Product Change Notice (PCN)

Subject: Assembly & sorting factory addition for RL78/G13, RL78/G14 LFQFP 80pin package products

Publication Date: 10/21/2024

12mm×12mm 0.5mm pitch 80pin LFQFP Package outline (Beijing/ASEKH)

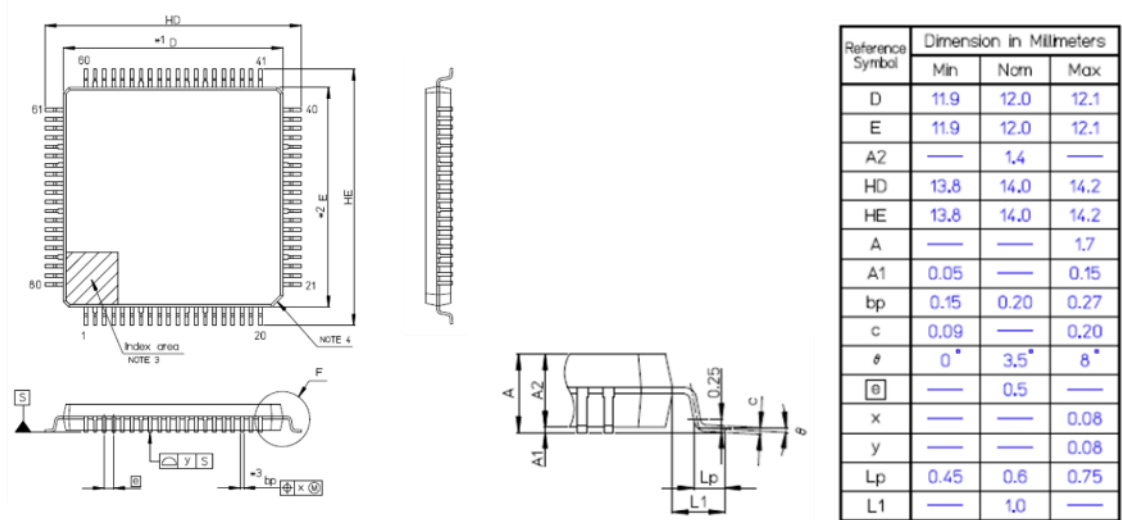
Form: Refer to the "Appendix" for detail.

Dimension comparison: 12mm x 12mm 0.5mm pitch 80pin LFQFP

KL,Beijing package symbols complied to JEITA standard, and Greatek package symbols complied to JEDEC standard.
